DOCUMENT CHANGE REQUEST

DCR number 337

Title: Thermistors (thermally Sensitive Resistors) Range 2000 to 100000 Ohms at +25C with a

Number: 4006/014

Matra Marconi Secification.:

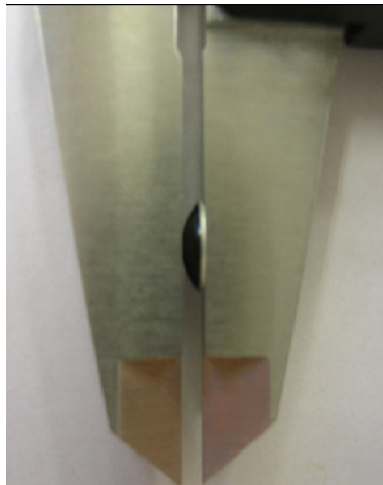
As stated previously “Flatness” is not adequately defined in ESCC 406/014 but can be found in old MMS specifications. The Flatness Specification is set at 0.005”Maximum Deviation.

This means that the part of the housing that is crimping the cable must not drop in excess of 0.005” from the Datum .

- 1) The means of fastening the leads must not drop below the mounting plane of the disc by more than 0.005”.

Issue DCR to add Flatness specification of 0.005” to all ESCC 4006/014 variants.

PROPOSED WORDING OF CHANGE FOR FIGURE 2:

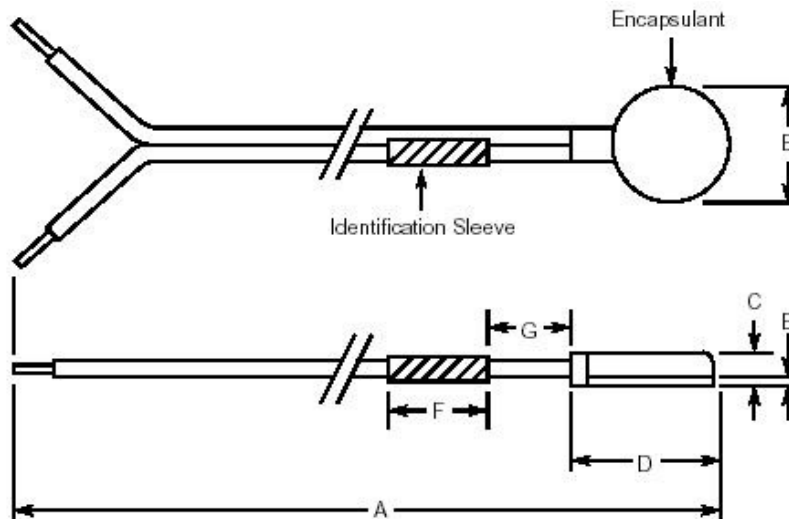
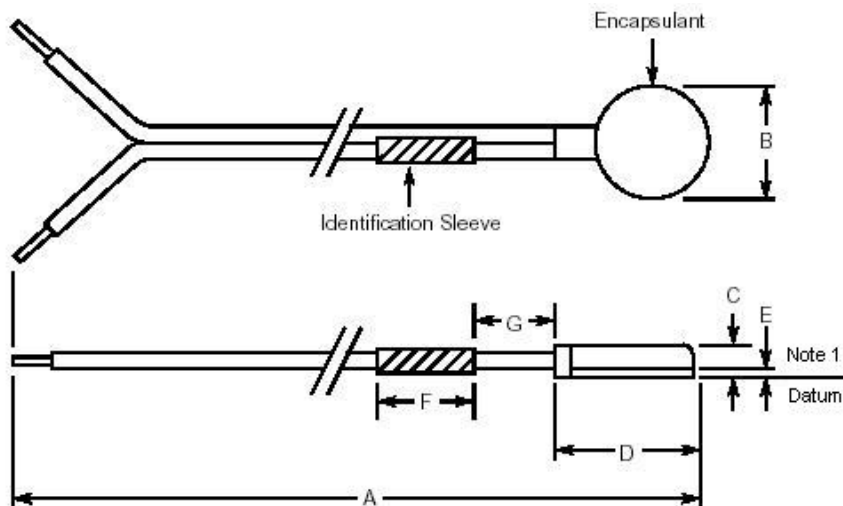
CHANGE FIGURE 2 FROM:

CHANGE FIGURE 2 TO:

JUSTIFICATION FOR CHANGE TO FIGURE 2:

Existing ESCC Detail specification 4006/014 does not adequately specify the Flatness of the Component. Components with inadequate flatness will cause problems when they are assembled by customers.

a) Rather than "datum" the usual ESCC term "mounting plane" be used in Figure 2
